Access Compliance Report Public Rights-of-Way (Curb Ramps)

Main Street: **SACHEM_WAY** Cross Street: **BARBERRY_ST** Location: **SW**

ADA ID: **RPAT211102150029** Ramp Type: **Type 1 - Perpendicular Diagonal** Initial Pass/Fail: **Fail** Overall Compliance: **No** Severity Score: **30**

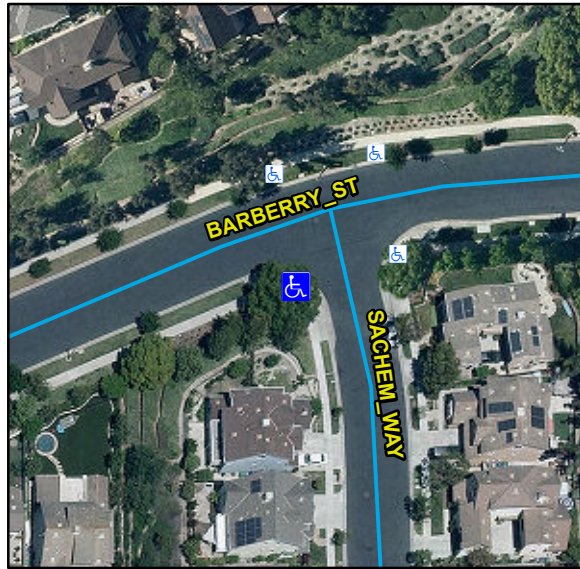
R304.2.2, R204.3, R304.5.3, STD 1115

Remove & Replace Curb Ramp With Two New Directional Ramps or Equivalent.
